# **A G E N D A**

## **Architectural Review Board**

**May 25, 2021 – 5:30 p.m.**

Preferred location

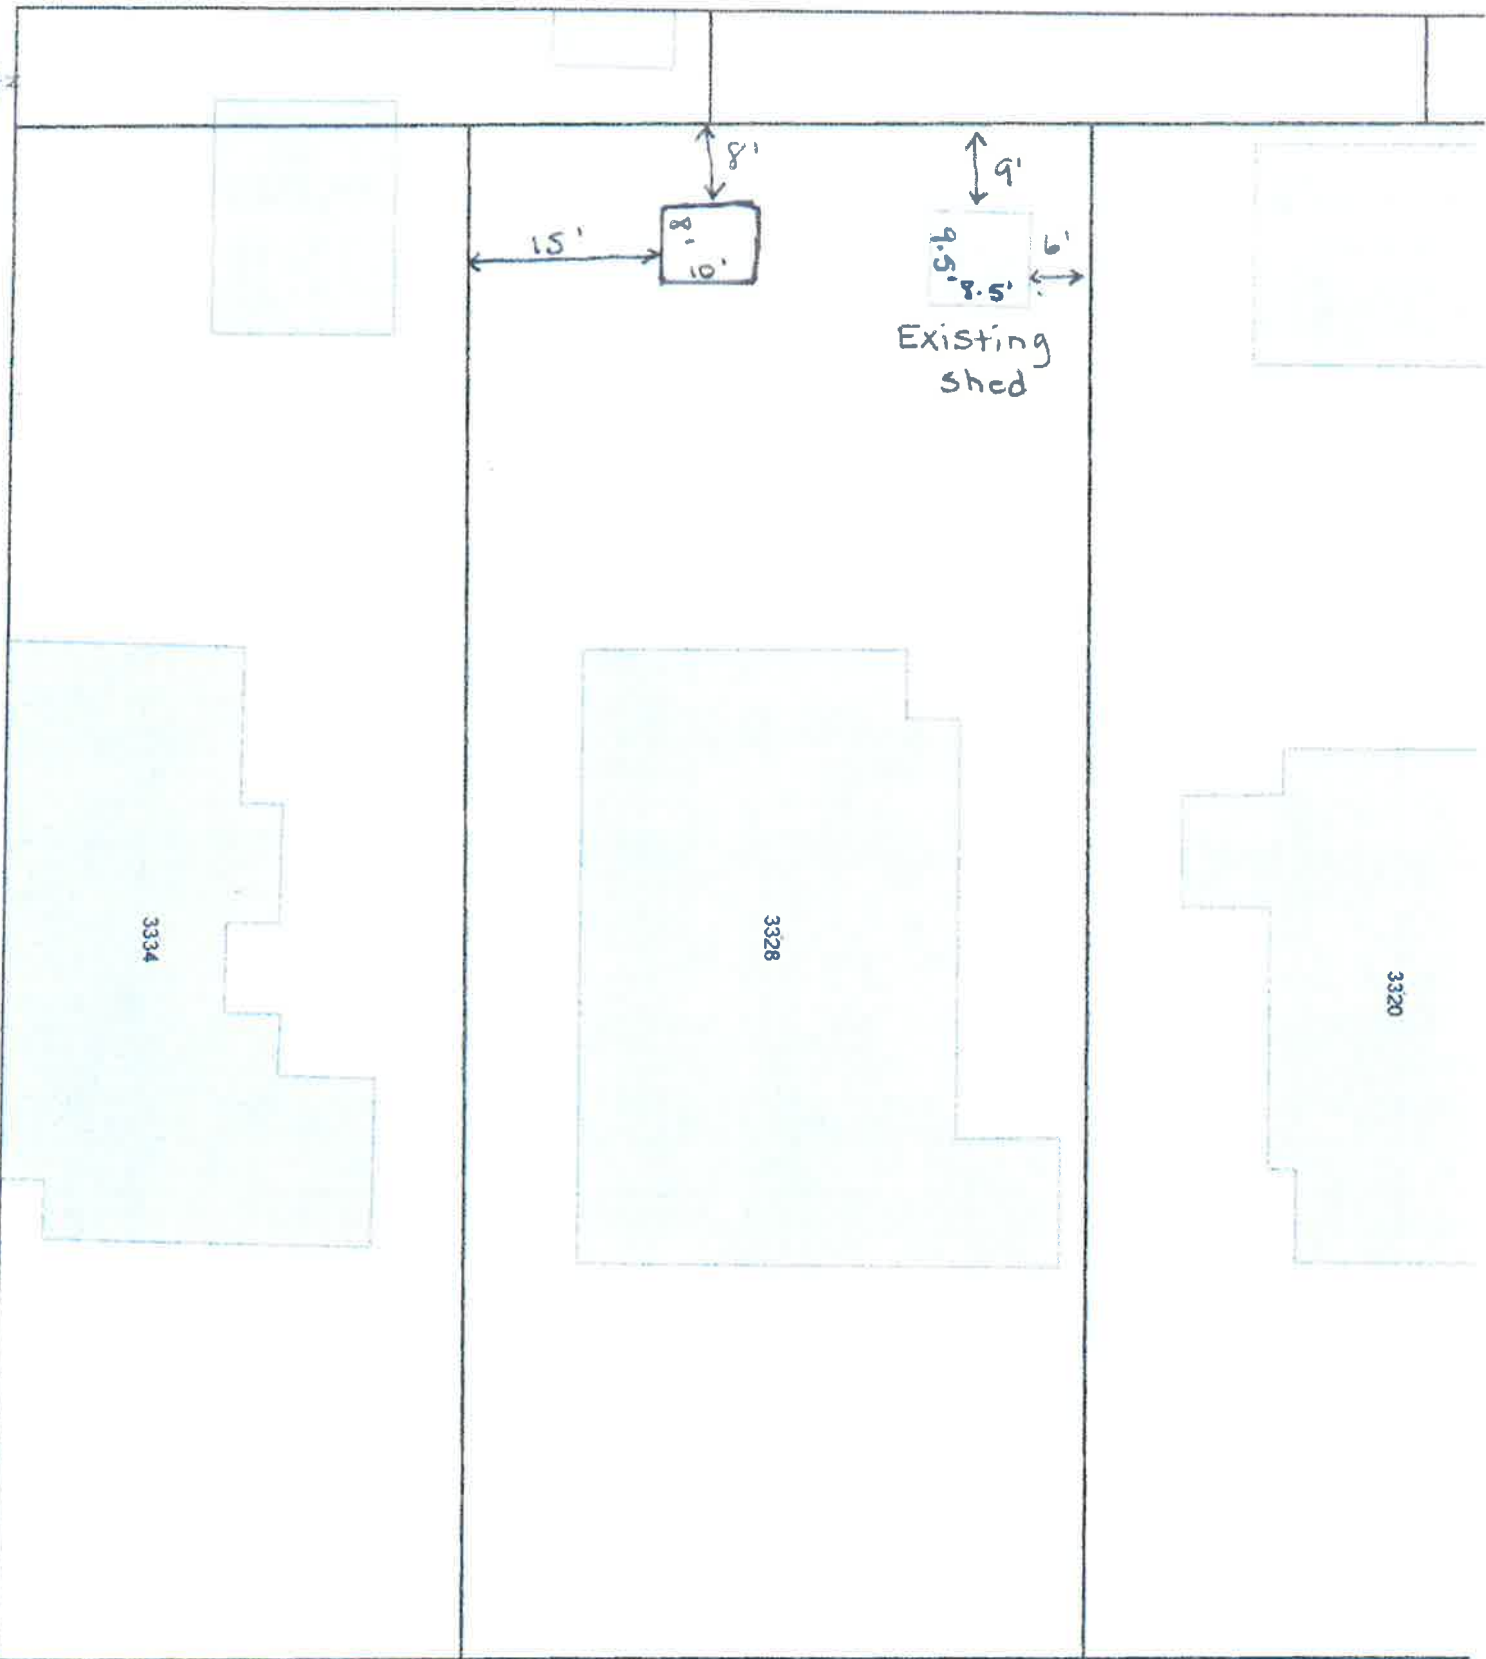
The petitioner is requesting permission to install an 8’x10’ Tuff Shed in the rear yard on an existing concrete pad. The preferred location meets the expedited review criteria in that it would not be visible from the street. The owners are trying to determine if the concrete is level enough to accommodate the building. The second location is at the end of the driveway where the remains of a metal shed stand. The shed will be painted white and roofed with charcoal shingles.

- No objection

1366 Woodward Avenue

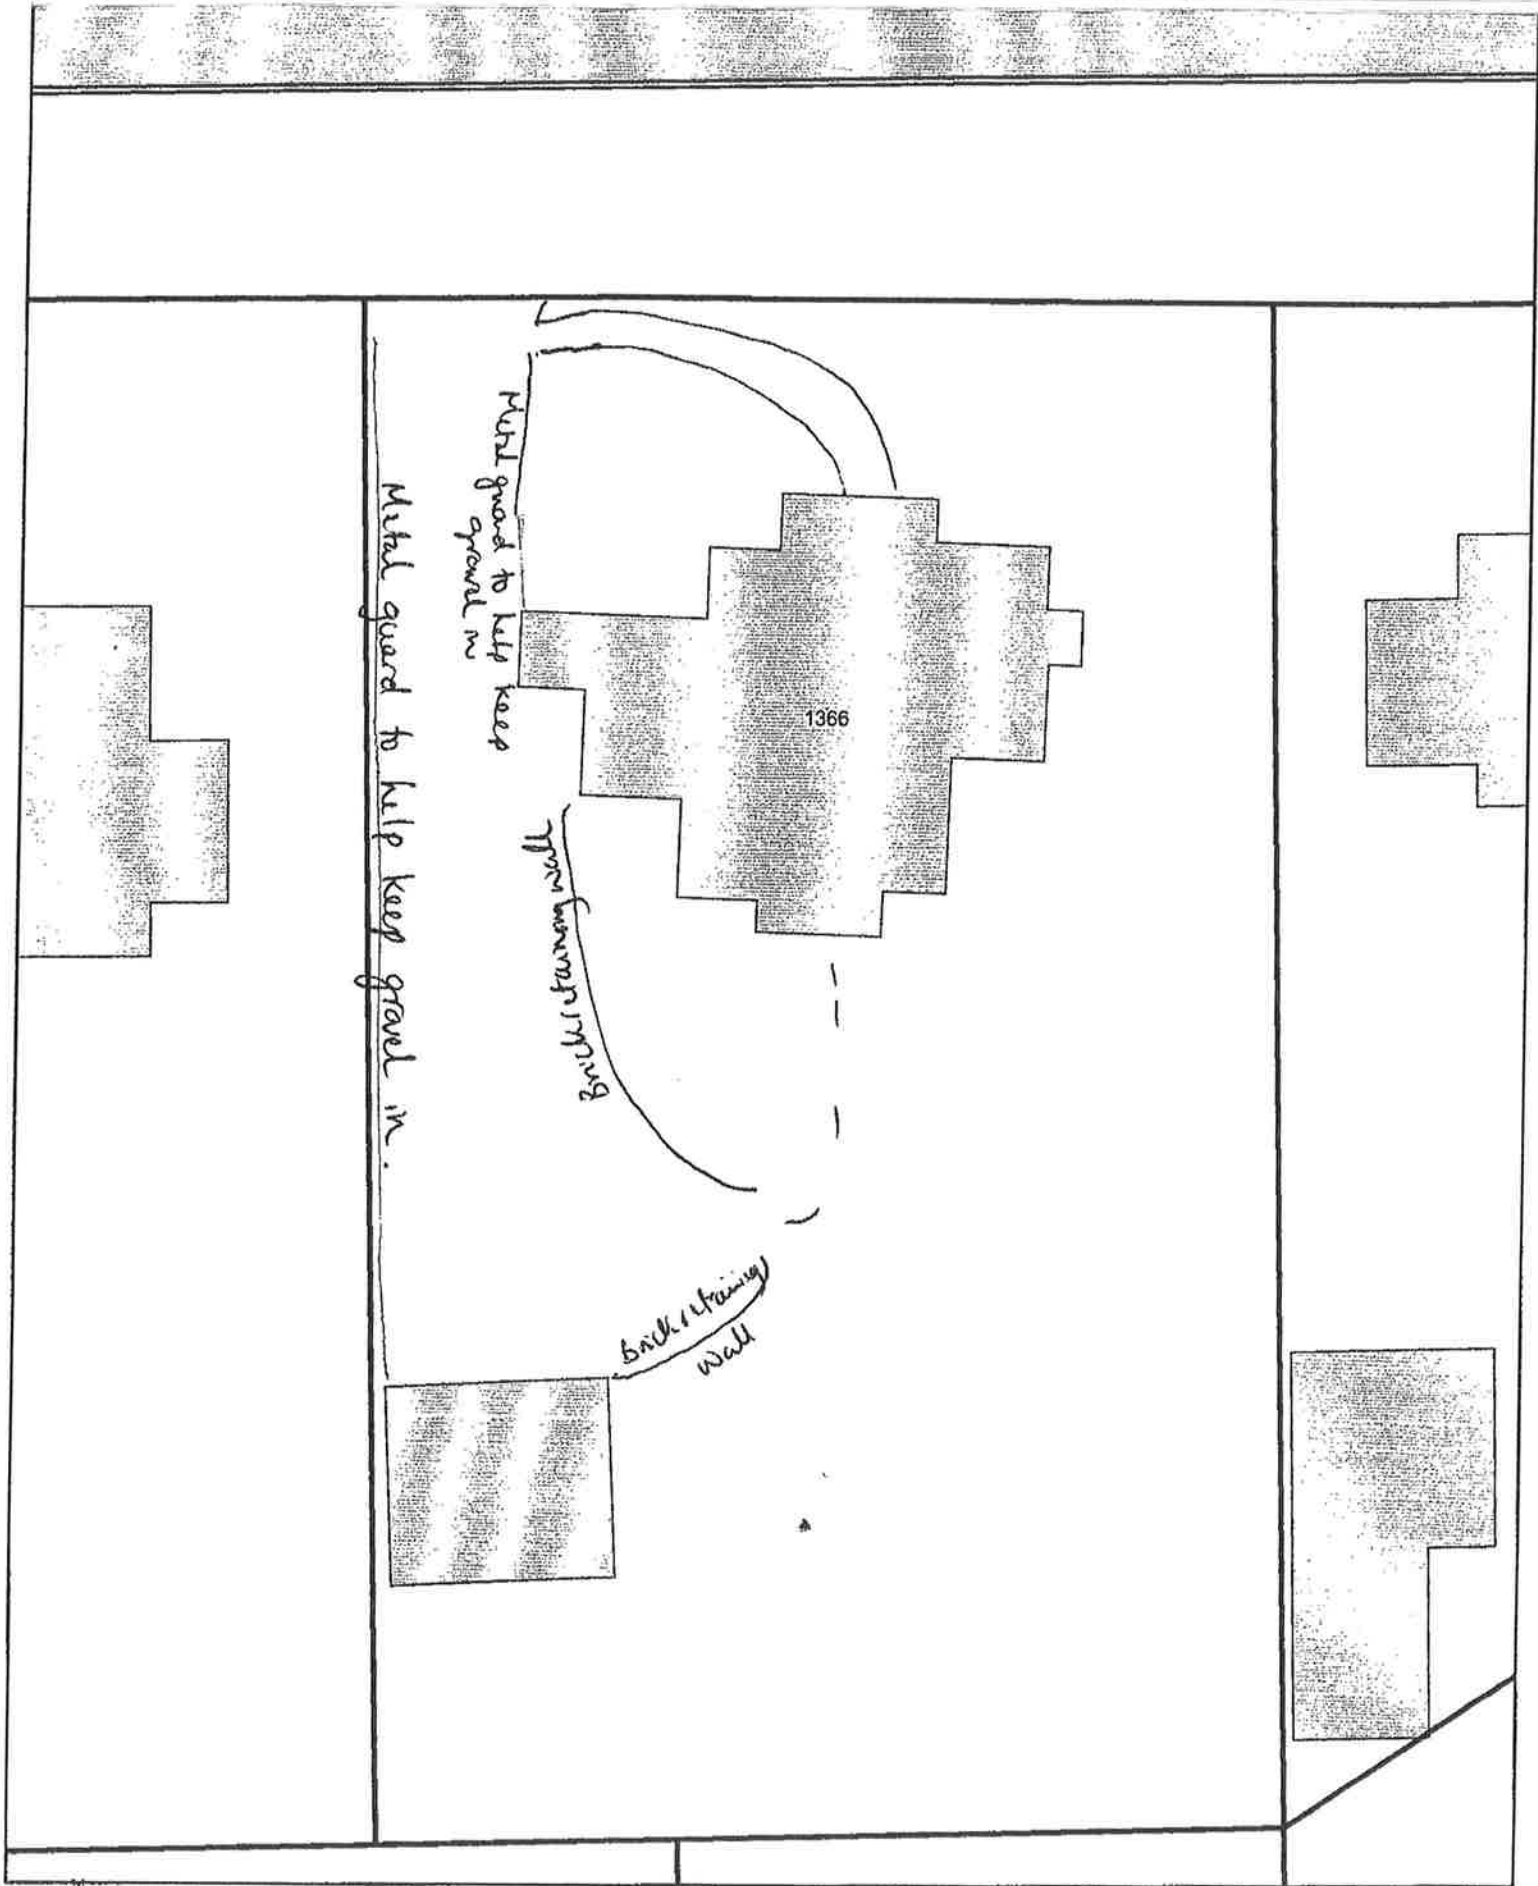
**REMARKS:** The petitioner is requesting permission to replace the existing concrete driveway with gravel in the existing footprint. The driveway will require a 2' retaining wall, brick, at the rear of the house to address an erosion issue. An 8' concrete apron will remain at the street.

- No objection

Site Plan  
scale : 1/8"=1'-0"  
1245 South Lawrence Street  
Montgomery, Alabama  
Lot Drainage type "B"  
Andy Bozeman plan #Trevor

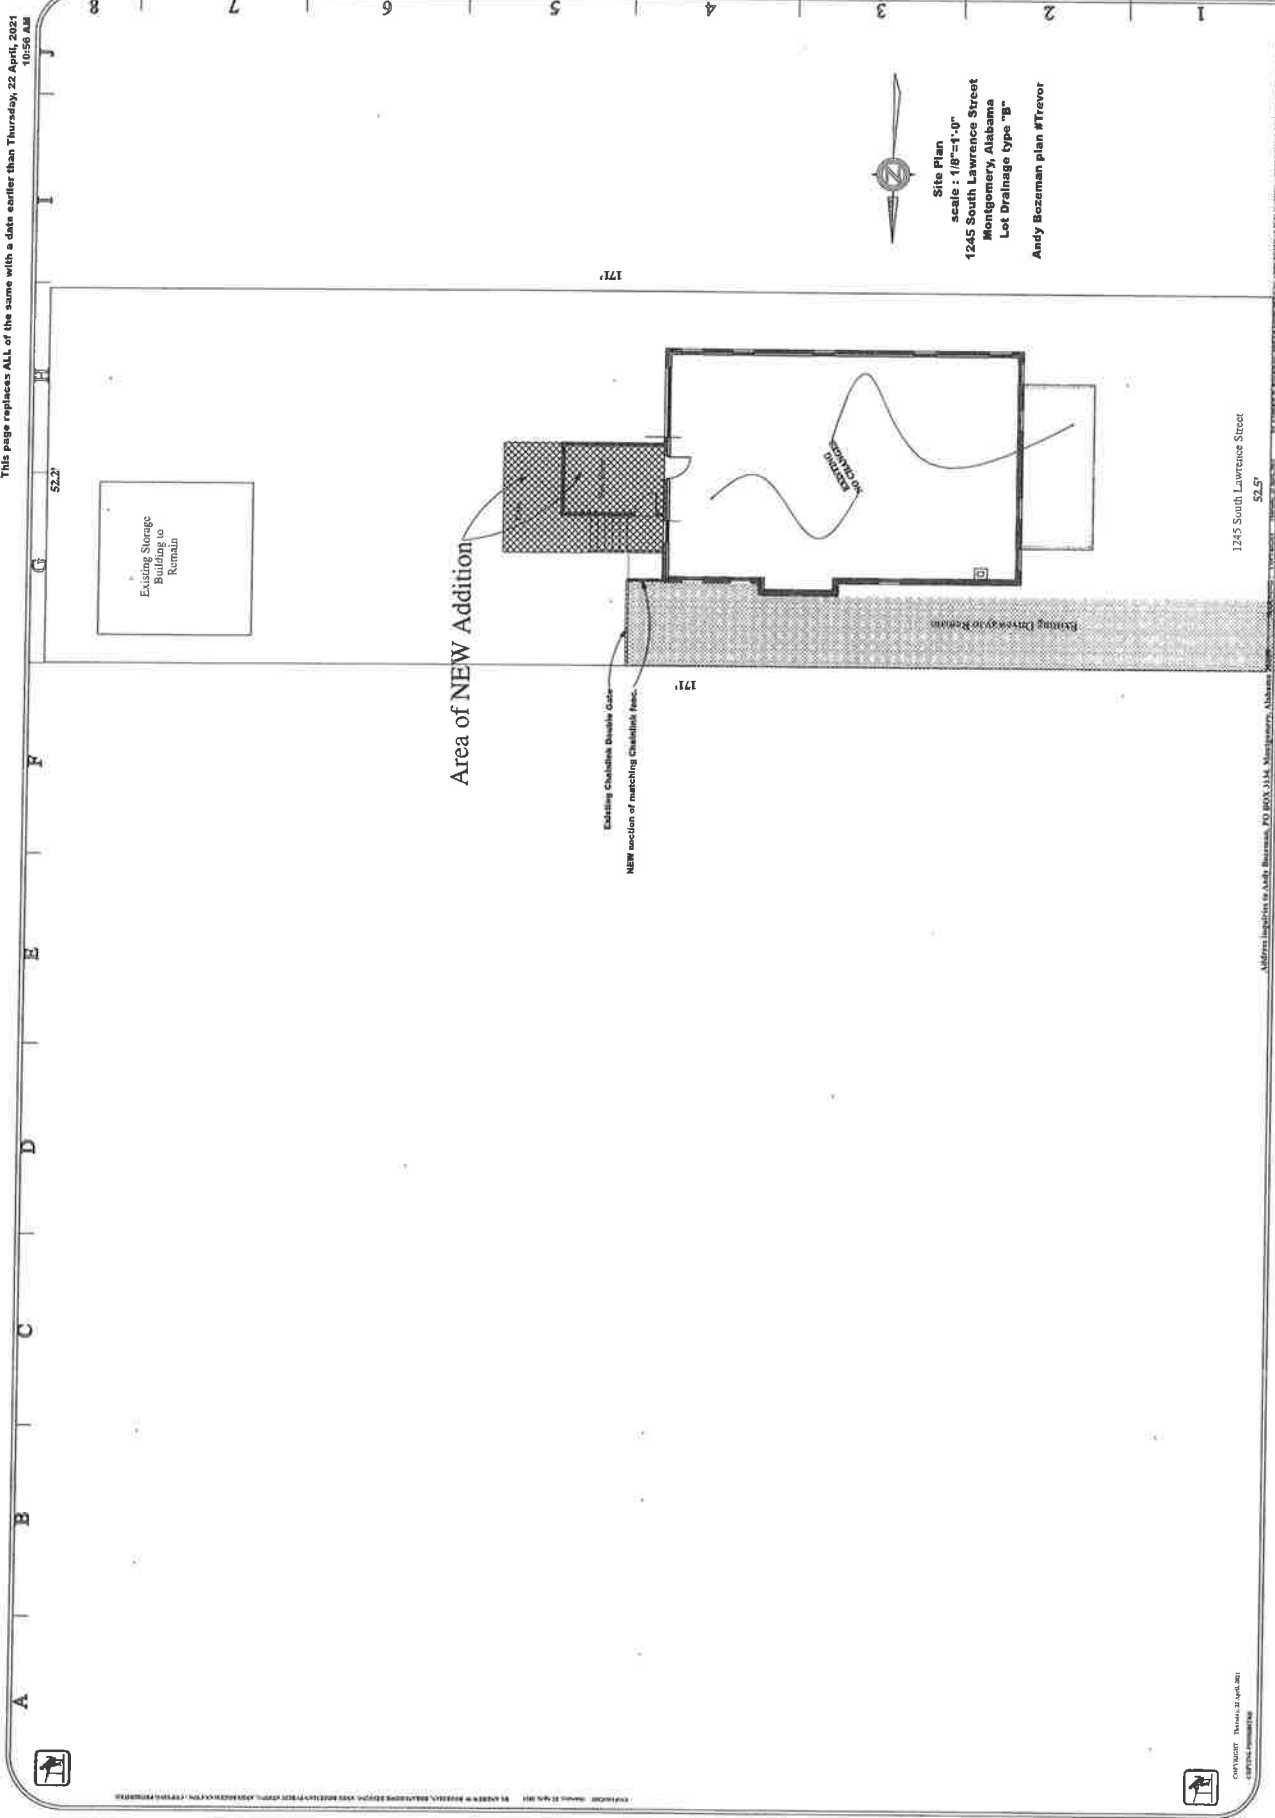
**REMARKS:** Request for approval of a rear 10'x14' addition as illustrated. The addition will use 9:1 windows to match the main house in wood true divided lite or double paned aluminum clad with simulated divided lites, selected from previously approved brands (e.g. Weathershield, Pella Architect, Jeld Wen); the new rear door will be a half lite steel or fiberglass door; exterior cladding to be T-111 or Hardie Panel with a vertical groove (main house is stucco); rubber membrane roof; wood stairs and landing; and addition to be painted white to match the house. The petitioner is also requesting approval for a screen door as illustrated.

- The Board has approved steel and fiberglass doors on rear elevations.
- No objection.
